NOTICE OF LOCAL PLANNING PANEL MEETING PUBLIC AGENDA

ITEM NUMBER	6.2
SUBJECT	Pre-Gateway Planning Proposal for land at 361-365 North Rocks Road, North Rocks
REFERENCE	RZ/2/2021 -
APPLICANT/S	EG
OWNERS	NextSense (Former Royal Institute for Deaf and Blind Children)
REPORT OF	Senior Project Officer

The purpose of the report is to seek the Parramatta Local Planning Panel's advice to Council on a recommendation to refuse a Planning Proposal at 361-365 North Rocks Road, North Rocks.

Figure 7: Proposed Height of Buildings

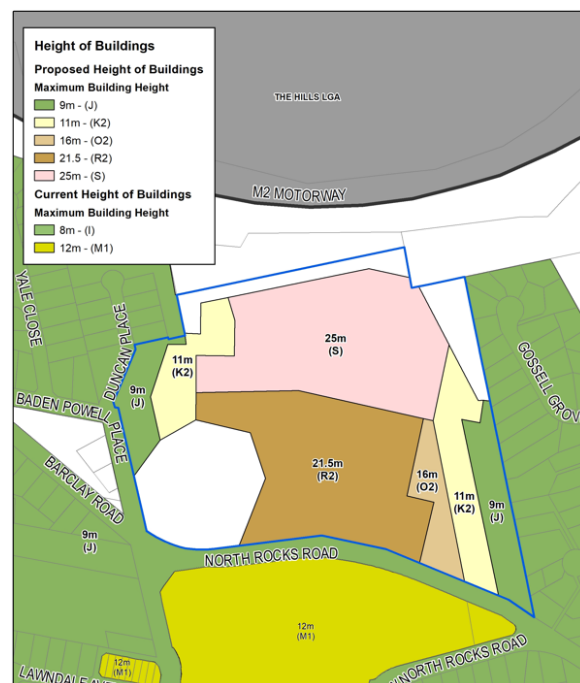
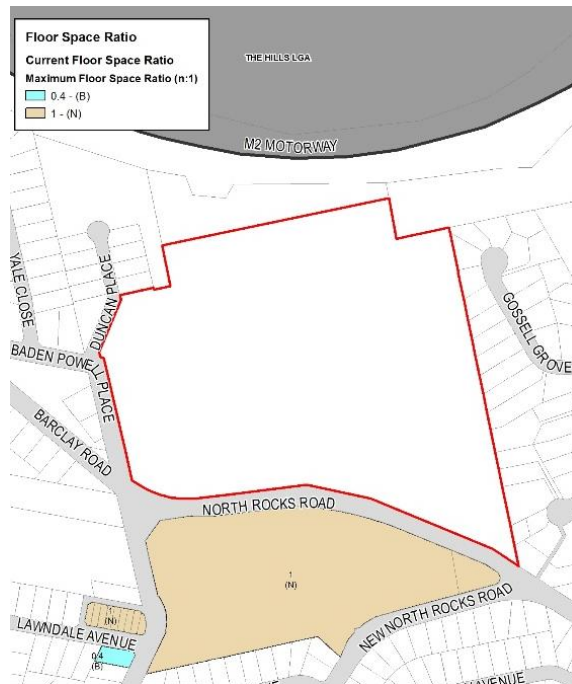
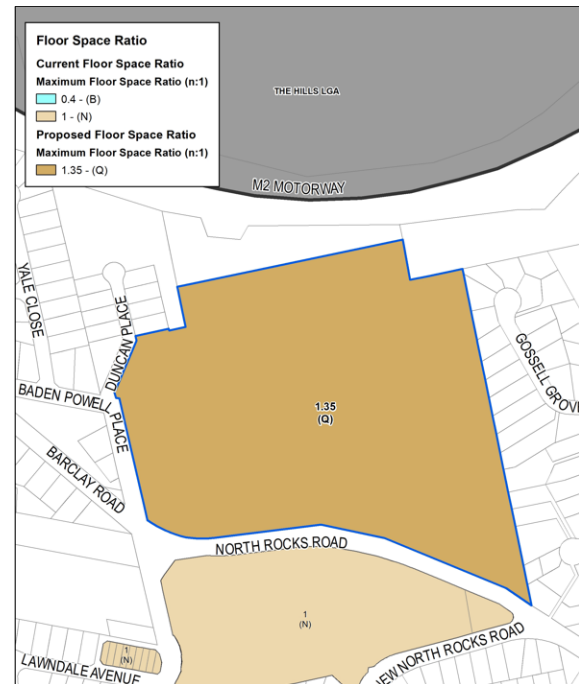
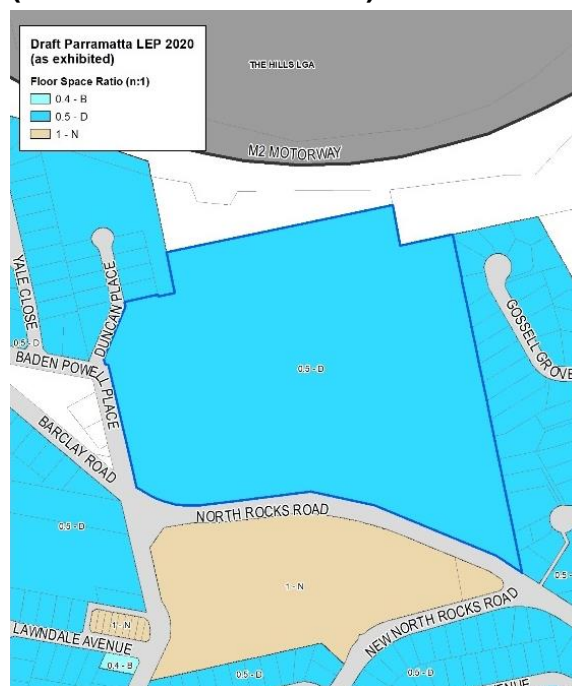
- b) Building height – The proposed number of storeys of 2 to 7 storeys is far removed from the surrounding low rise residential area and the low scale shopping centre. The proposal to locate more height within the suppression of the landform still results in visual impacts from within the site.

31. Furthermore, preliminary testing by Council officers found that to achieve the proposed gross floor area within a compliant building footprint, this would require up to 2 additional storeys than what is proposed by the Applicant. The potential for 9 storey buildings would not be supported on the site. The information submitted by the Applicant presents deficiencies which puts into question whether the aspired development parameters can be achieved through the proposed LEP controls.

Figure 12: Cross-section showing local terrain with the subject site and adjacent shopping centre

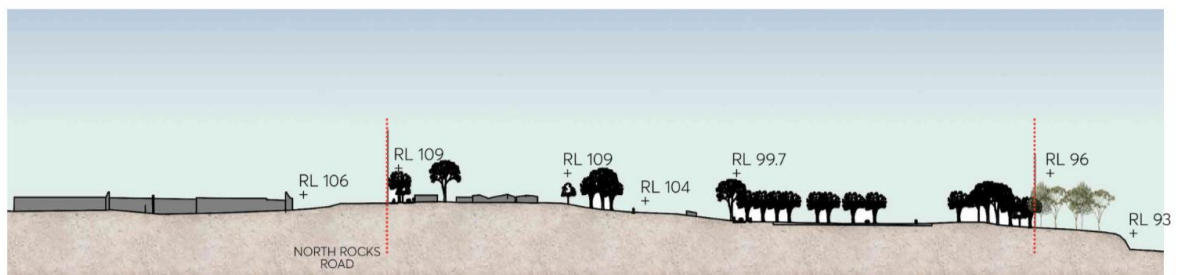
43. Topography - The proposal presents building envelopes that do not positively respond to the steep topography, with several envelopes positioned on steep embankments or in gullies which will result in significant fill. Furthermore, the proposed 4-6 storey built form interface to North Rocks Road is inappropriate noting the fall in topography to the south and the single storey shopping centre sitting lower within the landform (refer to **Figure 12**).
